Report to the Future Melbourne (Planning) Committee

**Planning Permit Application: TP-2015-906
88 Park Street South Yarra**

DELEGATED PLANNING APPLICATION REPORT

Application number:	TP-2015-906
Applicant:	George Nedovic
Address:	88 Park Street, SOUTH YARRA VIC 3141
Proposal:	Demolition of the existing dwelling and construction of a new two storey dwelling
Date of application:	7 October 2015
Responsible officer:	Oh Young Lee

TITLE: **SITE CONTEXT PLAN**

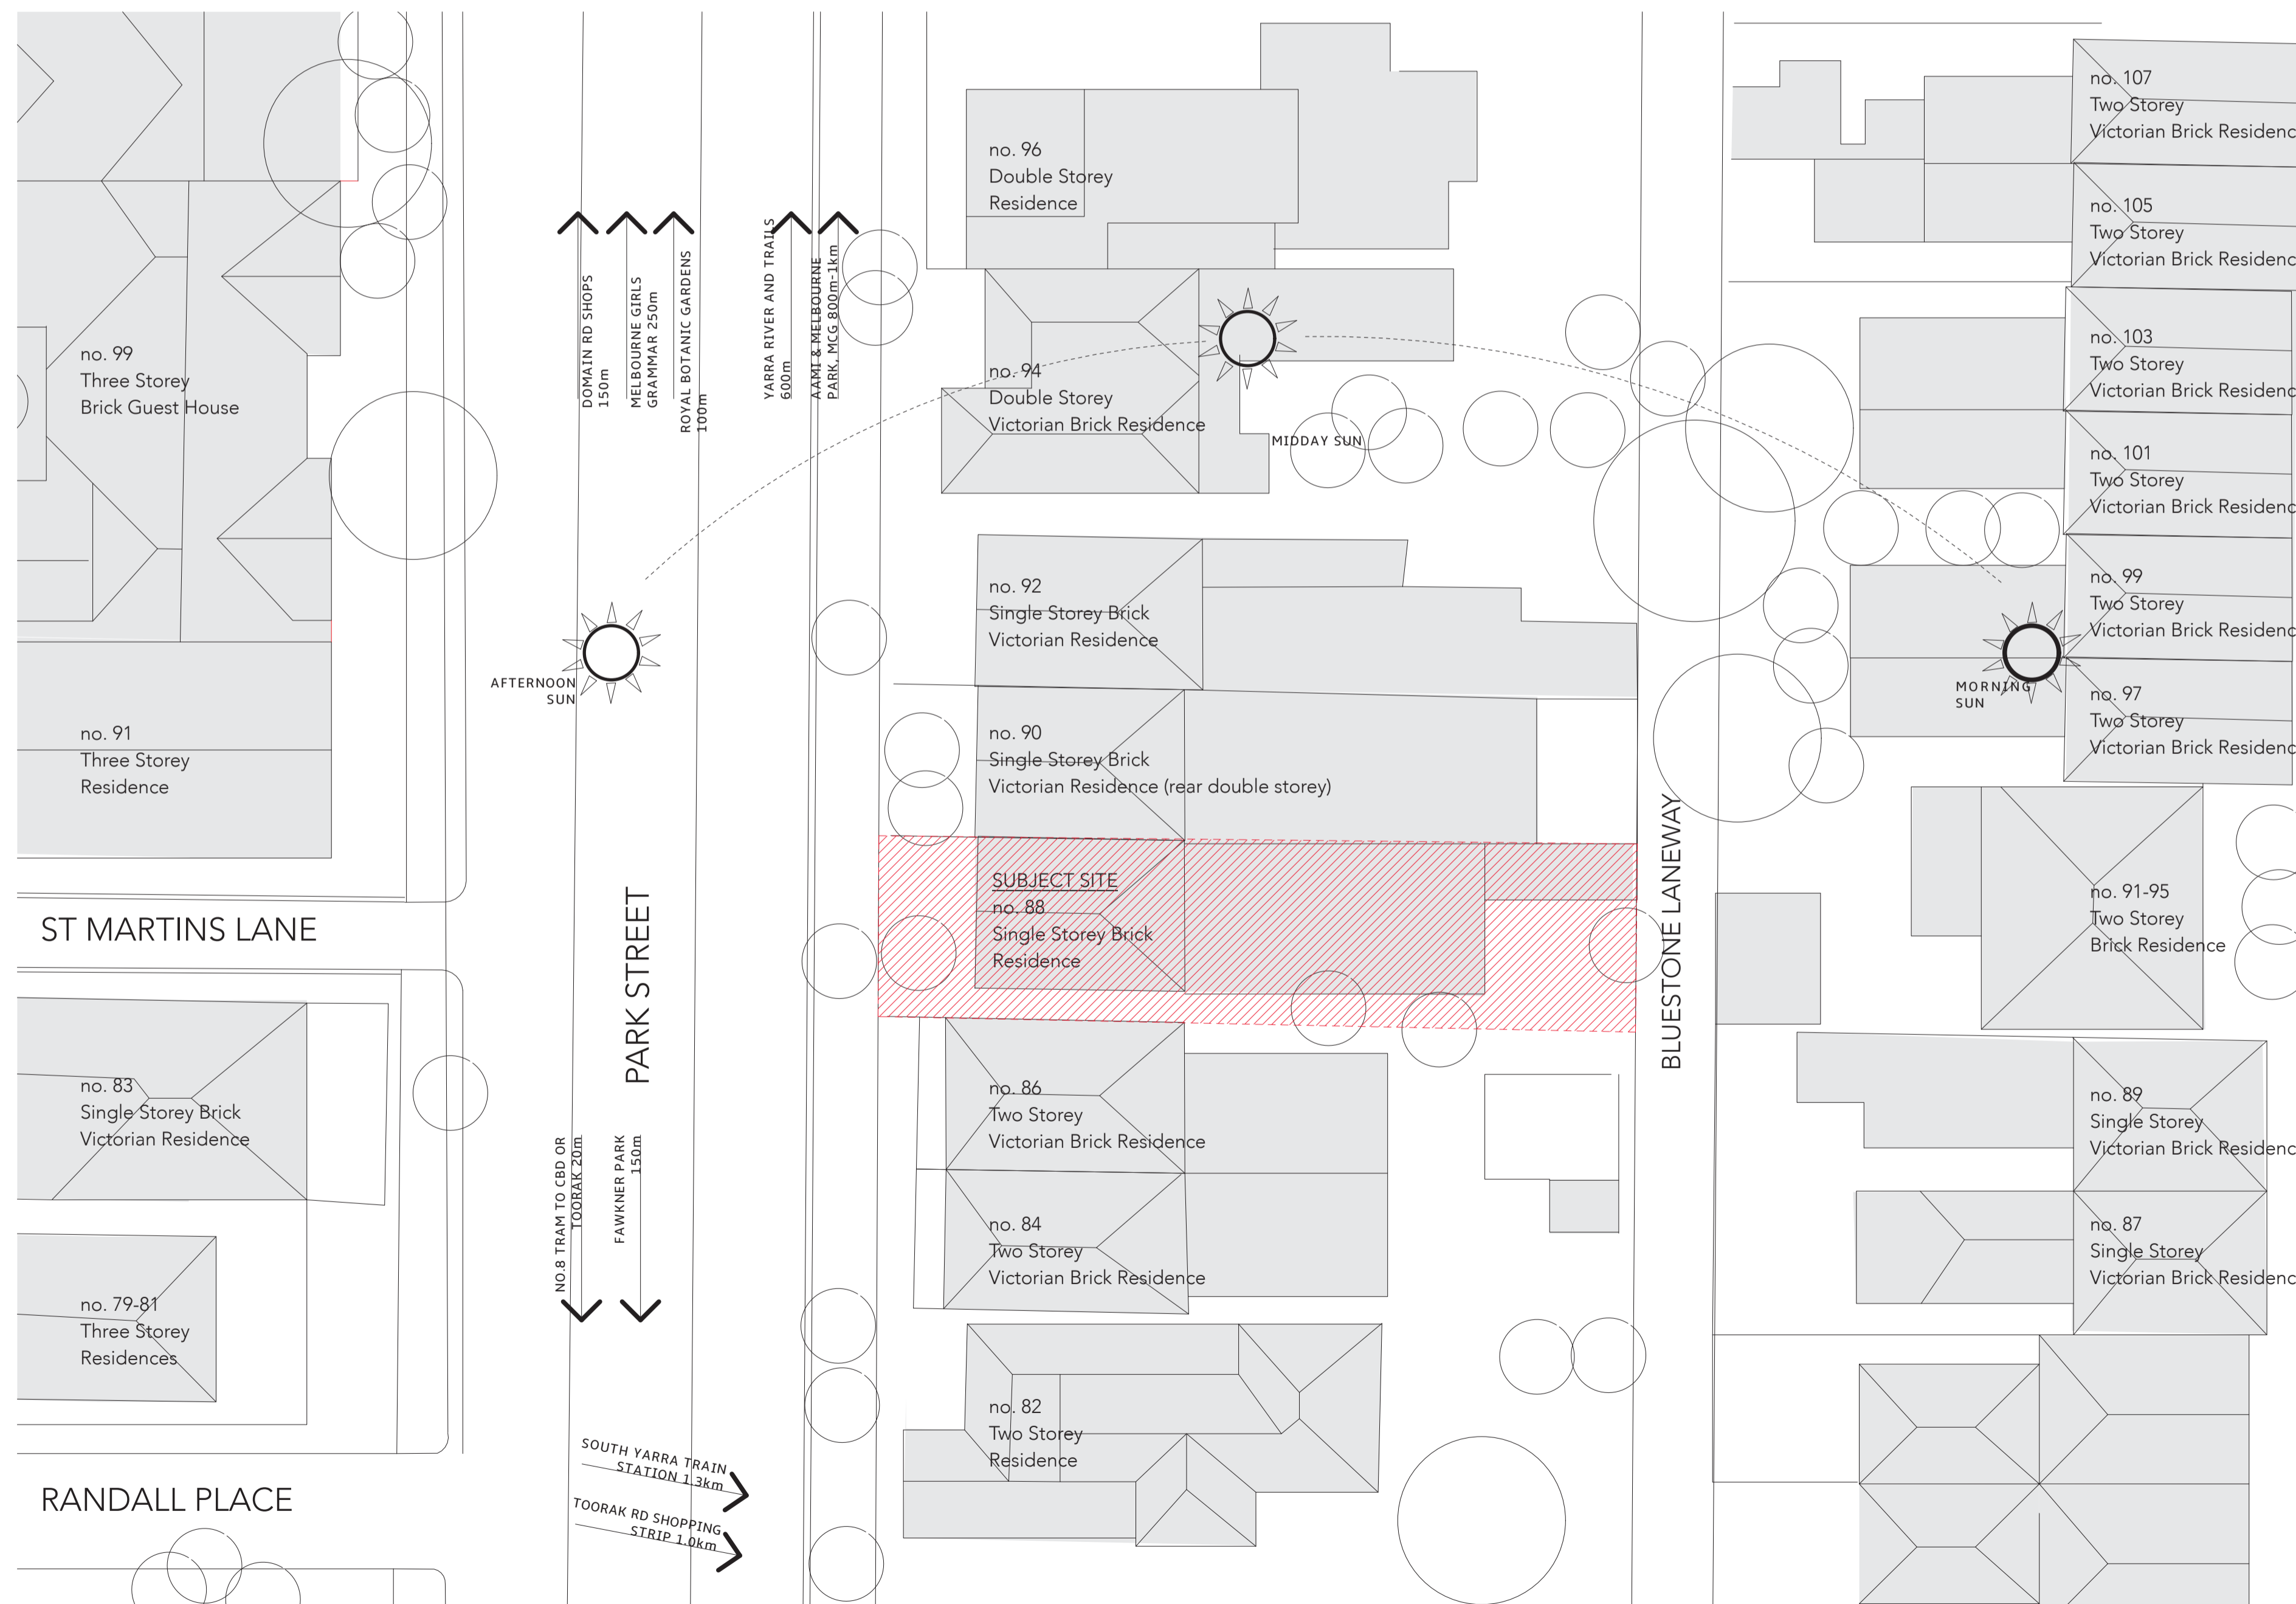
Inaccurate notation of Nos. 84 and 86 Park Street as single storey on the plans

These buildings are two storey Victorian terraces as described in section 1 of this report. The site context plan submitted by the applicant also shows these buildings being two storey. It is therefore considered a typo in some of the drawings which has not affected this assessment.

Proposed First Floor Level 1:100

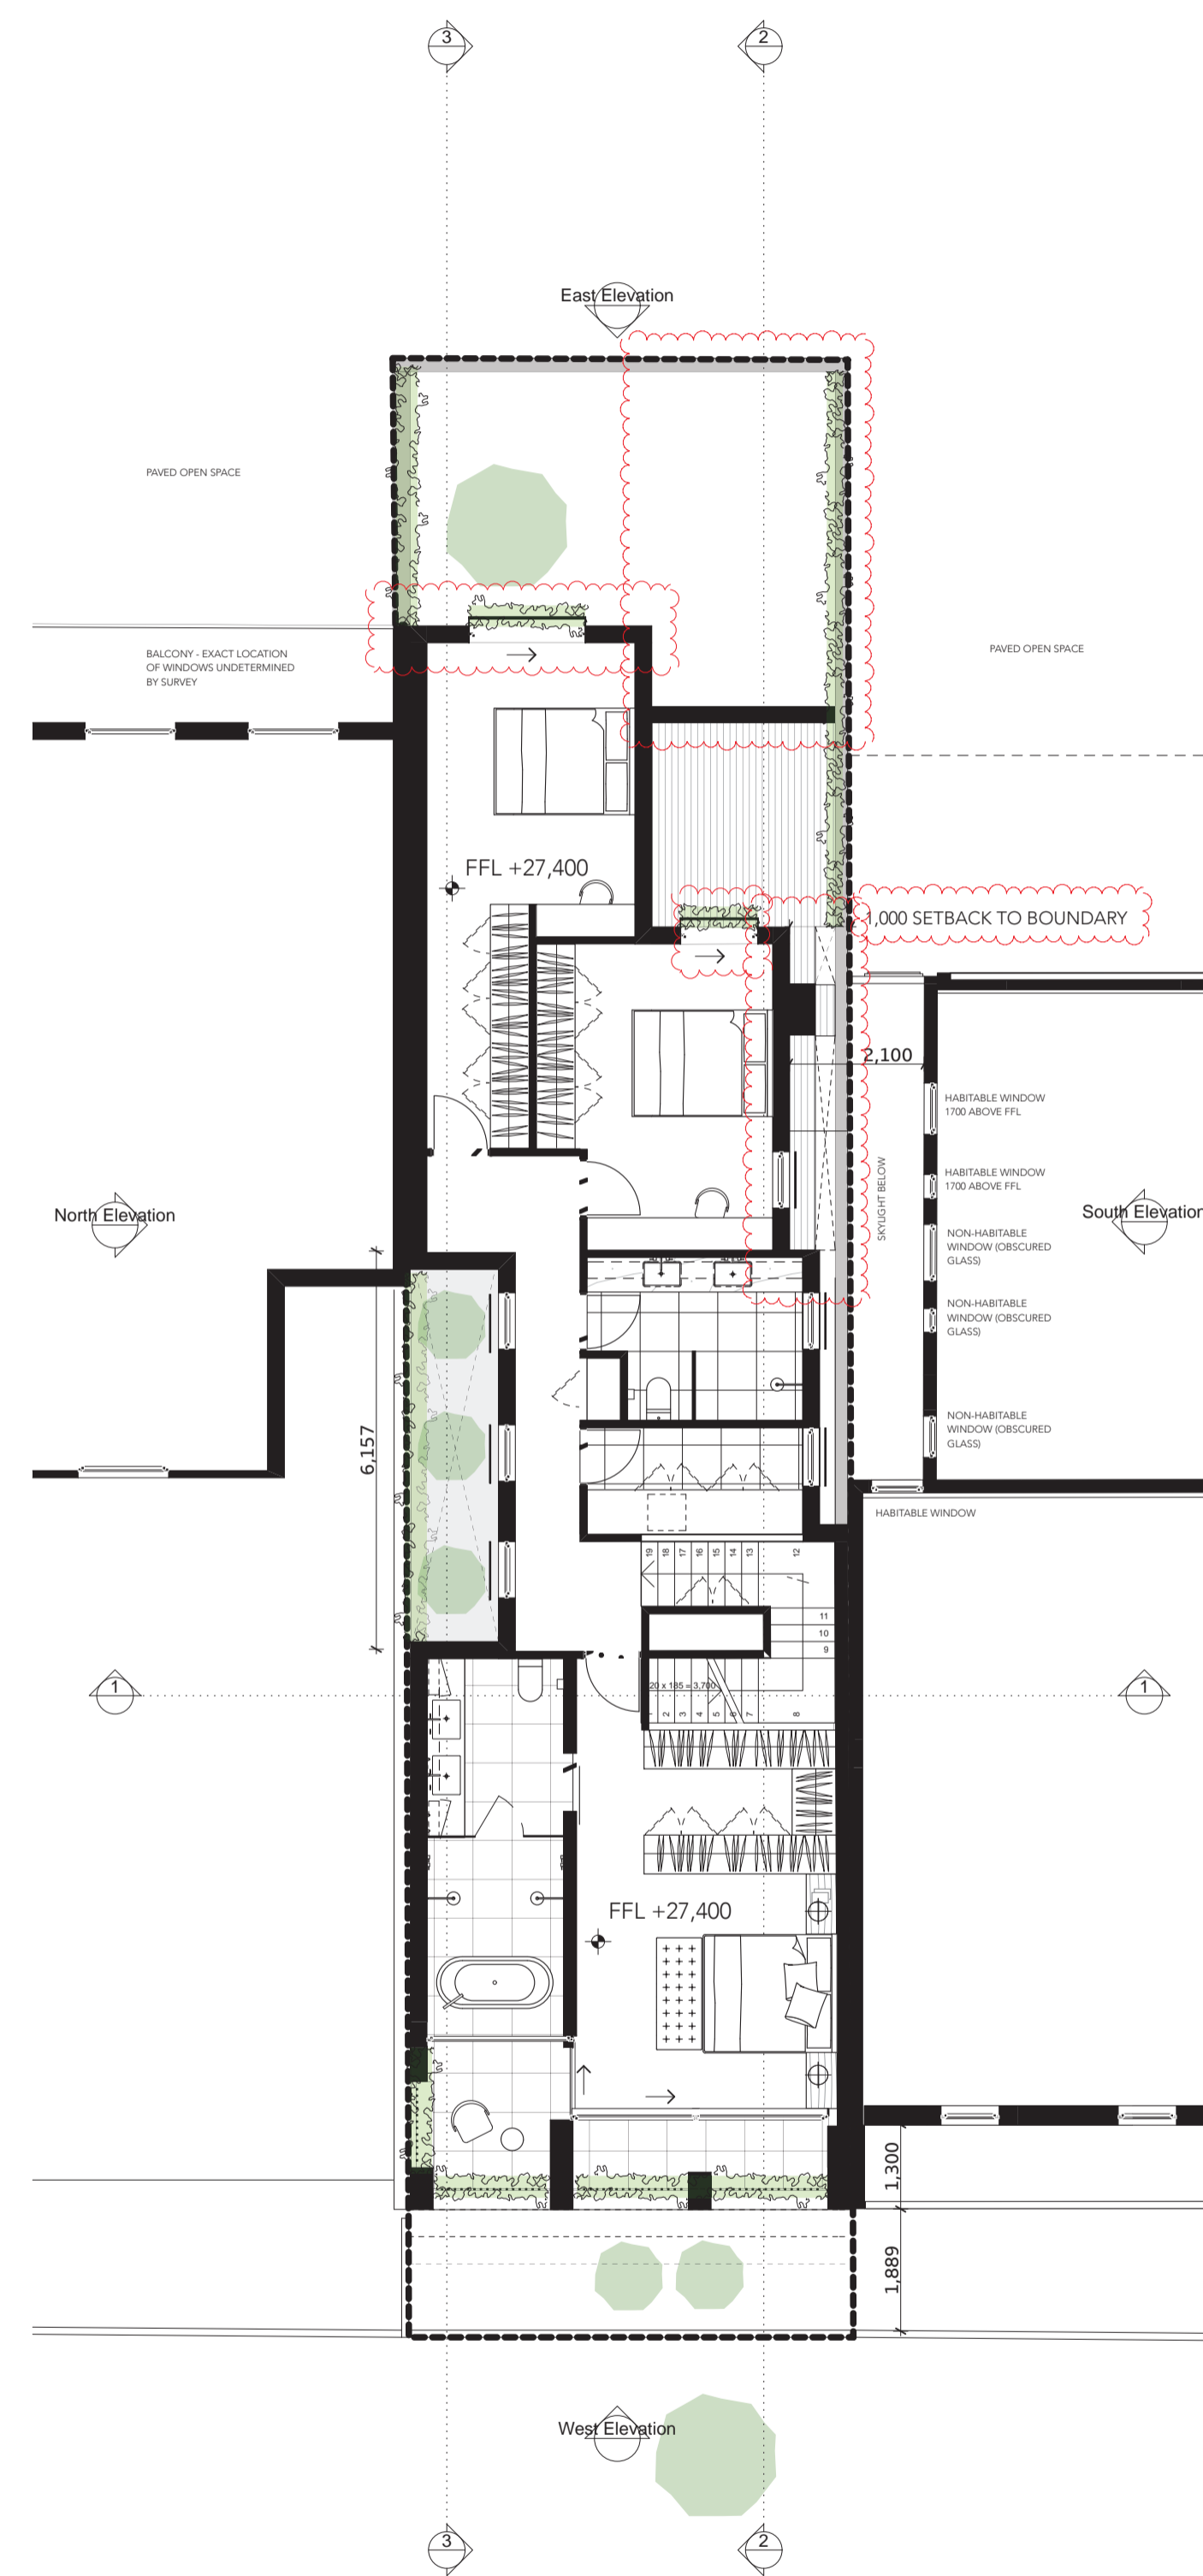
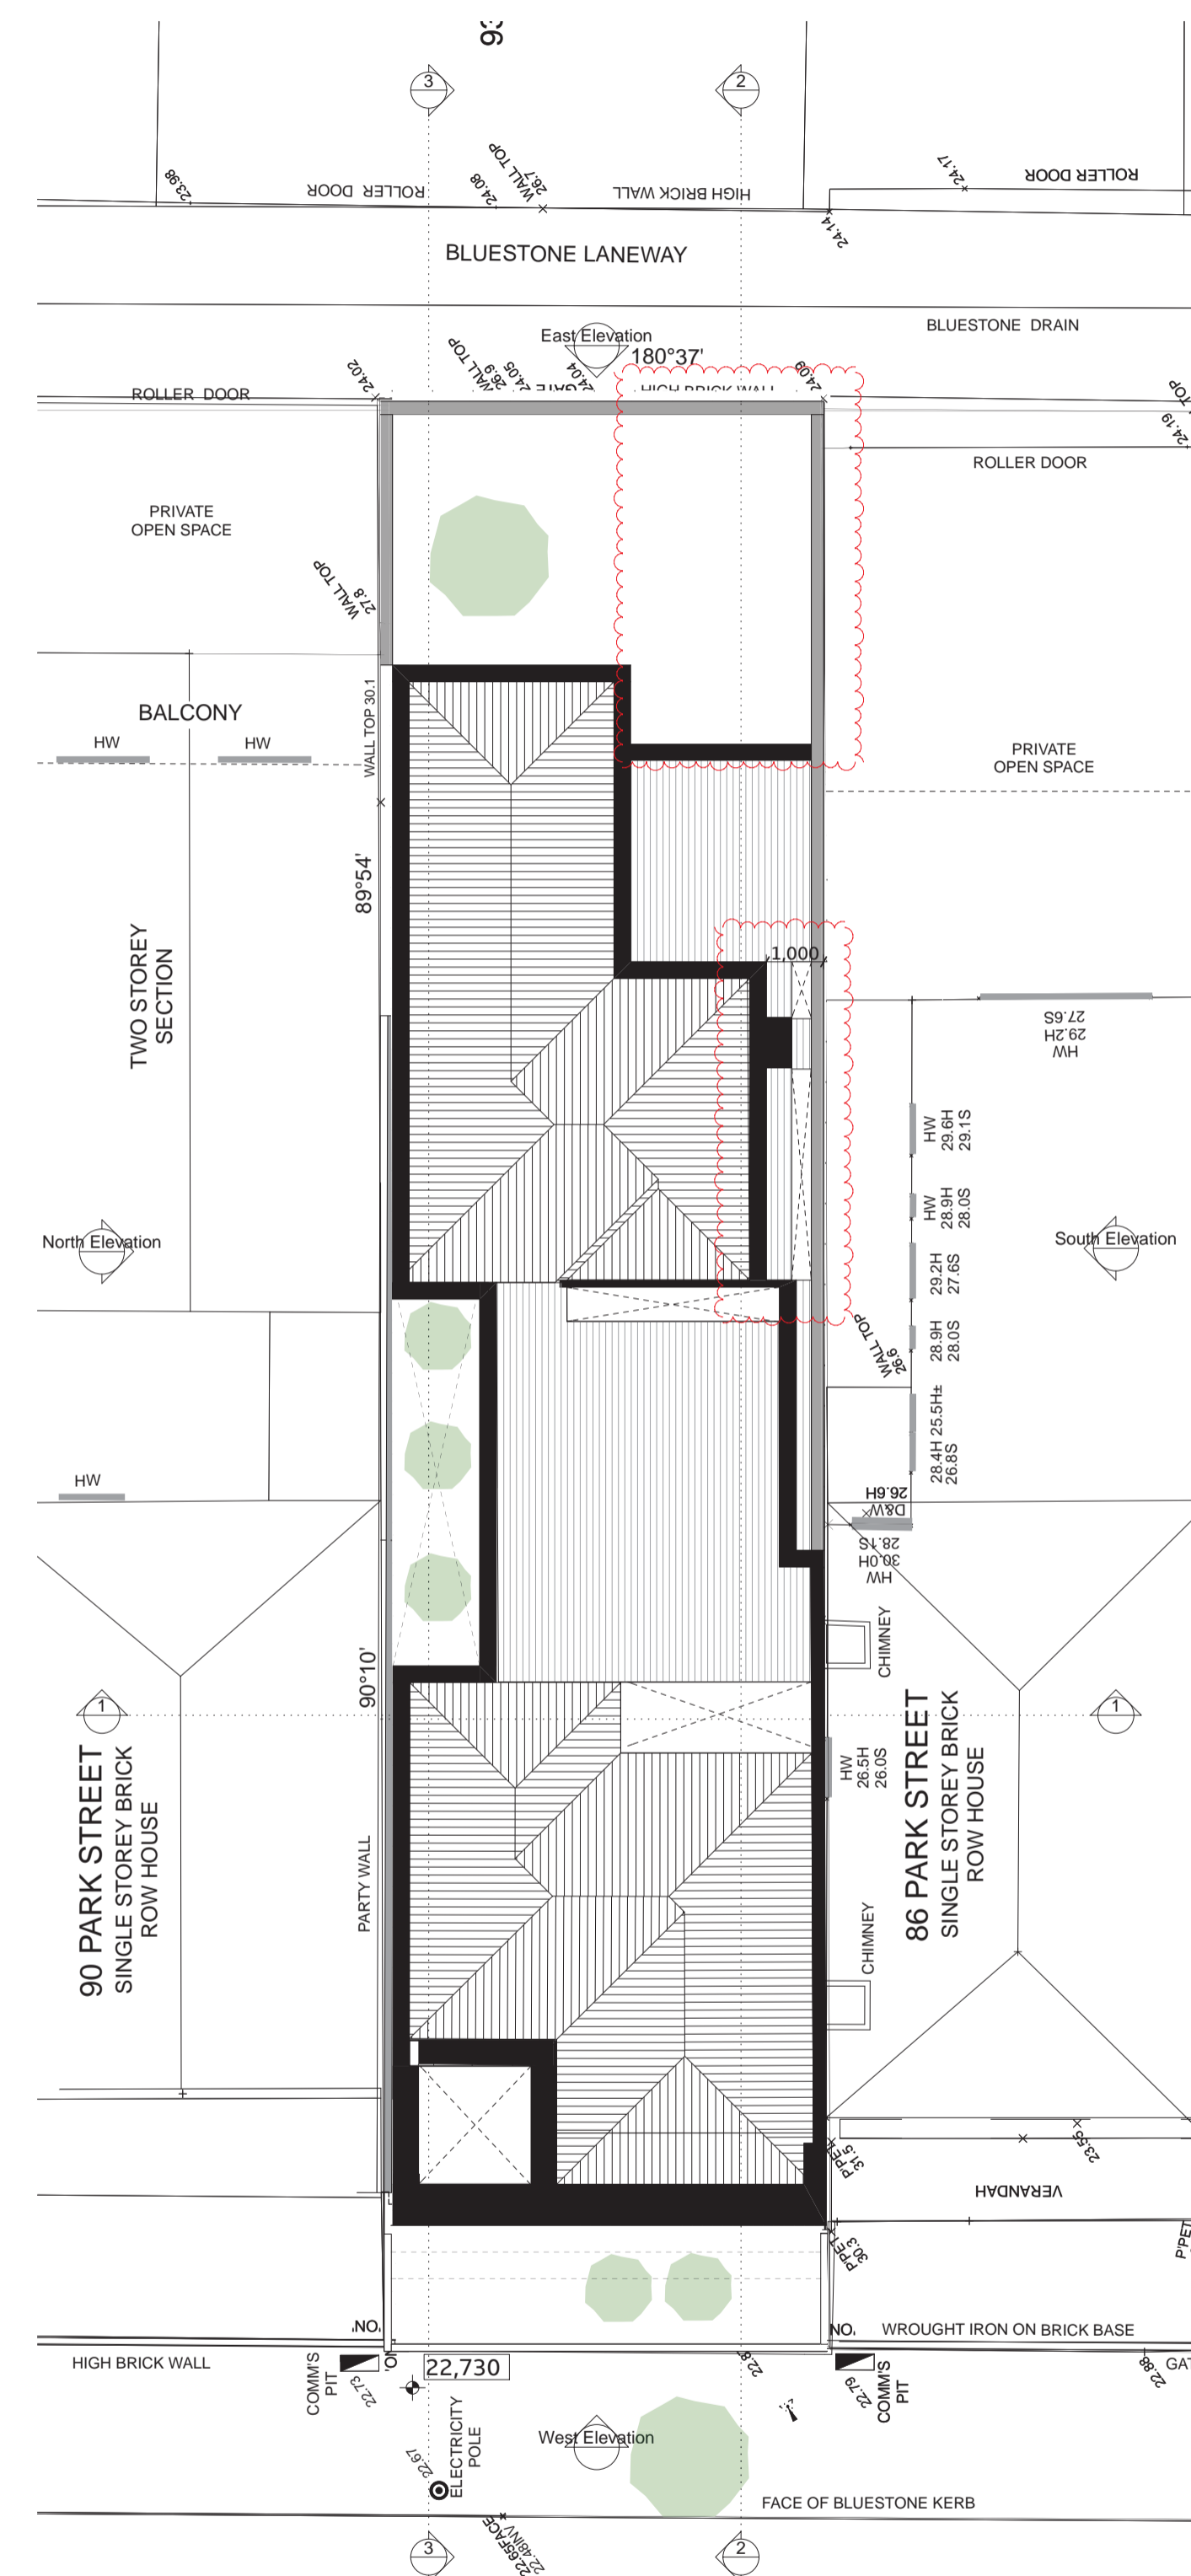
7. Recommended conditions require screening of two east-facing bedroom windows at first floor, further side setback at the mid-point of first floor and the submission of landscape concept plan, all of which will further ensure that the amenity of adjoining properties is not unreasonably impacted.

The setback requirement of the first floor wall to the south boundary, based on the wall height of first floor being 3.7m above FFL, is 1.03 metres. The proposed setback on the first floor, as shown on the revised plans submitted on 3 April 2016, is 0.5 metres in the mid-point to bathroom and laundry and 1 metre to a bedroom. It is noted that since the submission of the revised plans, the applicant has agreed to provide a minimum of 1 metre setback to bathroom and laundry as well (via a condition). The following discussion is therefore based on a 1 metre setback from the south boundary.

Whilst the proposed setback marginally exceeds the standard it is not considered to adversely affect the amenity of the adjoining dwelling at 86 Park Street. The dwelling at No 86 has two small windows on the north elevation which would not currently provide a significant amount of sunlight. Together with the existing setback of 1.15 metres provided on the first floor of 86 Park Street, the proposed 1 metres setback will form a sufficient light court (a total of 2.215m).

The plans show 1.2 metre high screens to both bedroom windows facing east. These windows have the potential to overlook the SPOS of 86 and 90 Park Street as well as 91 and 93-95 Leopold Street. A condition will require the screen to these windows to be increased to 1.7 metres to comply with the standard.

1. Prior to the commencement of the development (including demolition or construction or carrying out of works) on the land, two copies of plans drawn to scale must be submitted to the Responsible Authority generally in accordance with the plans received on 3 April 2016 but amended to show:
